Hardware Findings & Recommendations

(H-3)

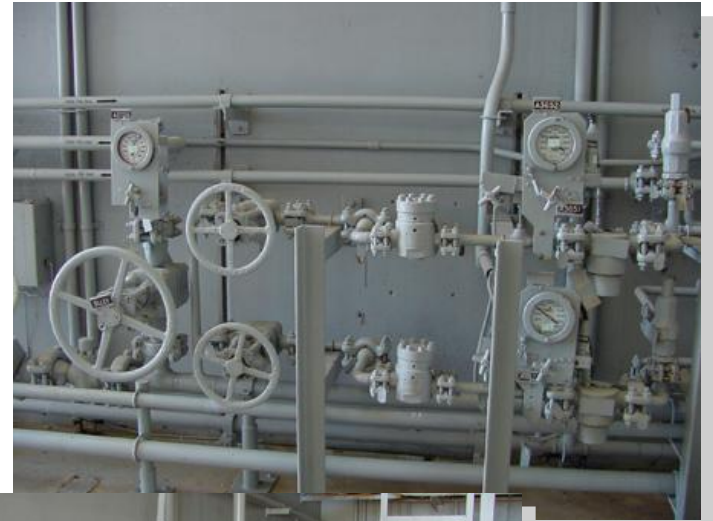
- At both Pads tubing in user panels and tubing in systems downstream of these panels will not be replaced by the GSS GN2 tubing replacement project
- GN2 tubing experiences known pitting problems.

- Need to address
- Selection of replacement tubing with a higher corrosion resistance is under development as part of the Pad tubing replacement project
 - Systems should use this new tubing

(H-5)

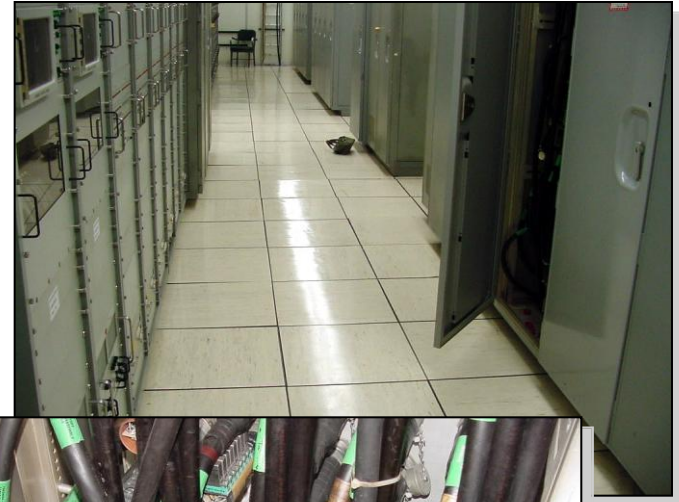
- Description
 - Not all Engineering departments may be aware of their hardware and component responsibilities
 - Responsibility for maintenance on the Receptacle Distribution rack in Pad room 210. Maintenance of cables that connect 28v DC power supplies to patch racks, and of the 28v DC power supplies themselves
- Recommendations
 - Clarify specific responsibility

(H-6)

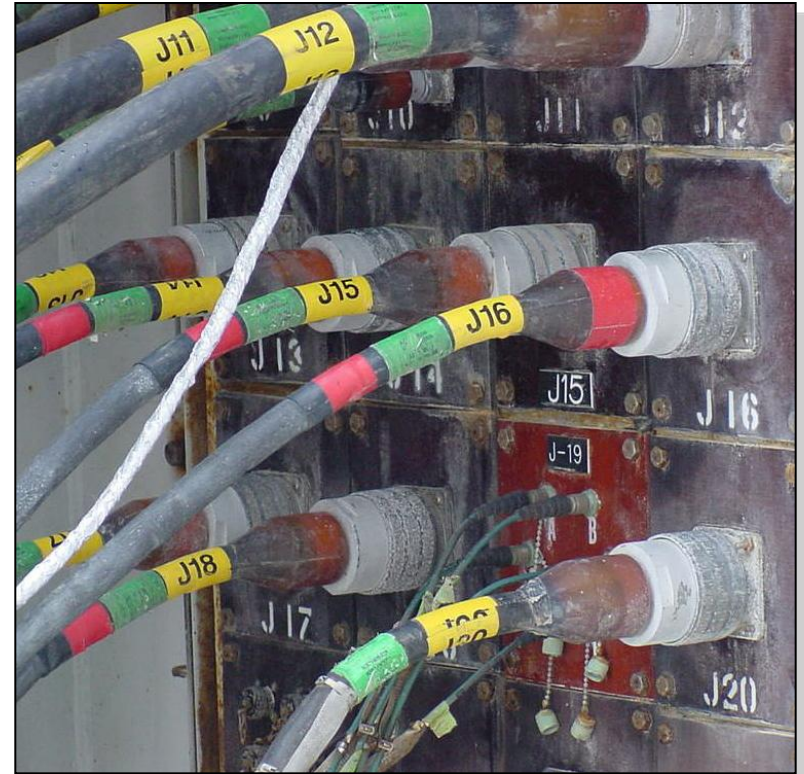
- **Description**
 - Sound Suppression cable connections on the MLP 9099 interface are interchangeable and can be mistakenly cross-connected
 - An instance of cross-connection was found on a recent flow
 - A large number of the protective caps for these connections are also untethered
- **Recommendations**
 - The 9099 Interface ERB Action Team is addressing this issue

(P-3)

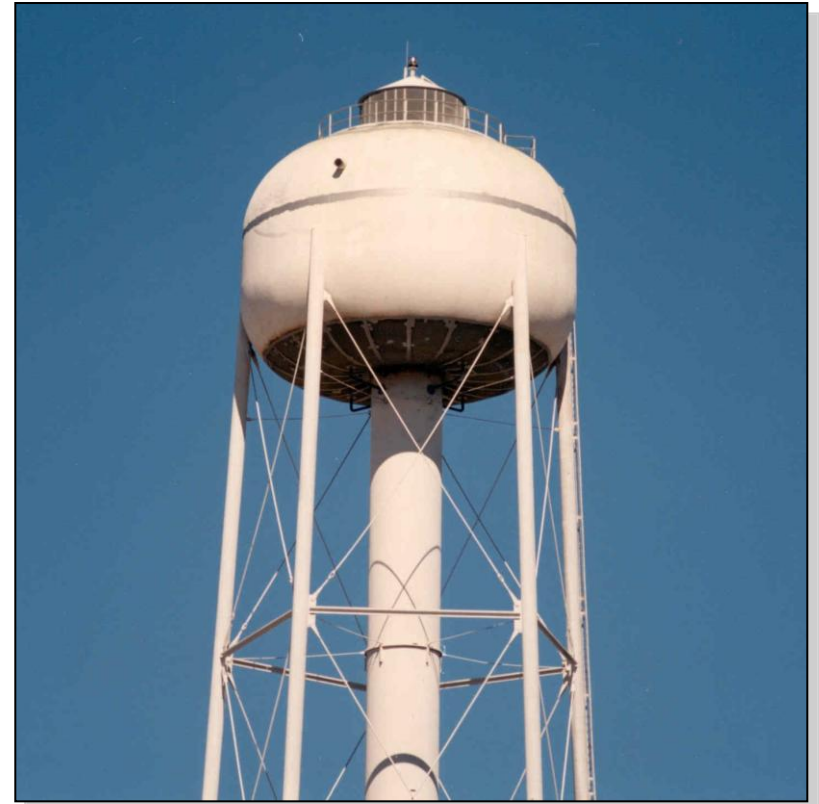
- **Description**
 - Interviews with Corrosion Control personnel suggested that some areas of the Sound Suppression valve complex require a more thorough washdown
- **Recommendations**
 - Review the post-launch procedure (S2005) to ensure an adequate wash-down rinses SRB residue and local salt sprays from Sound Suppression lines and associated component valves, etc.
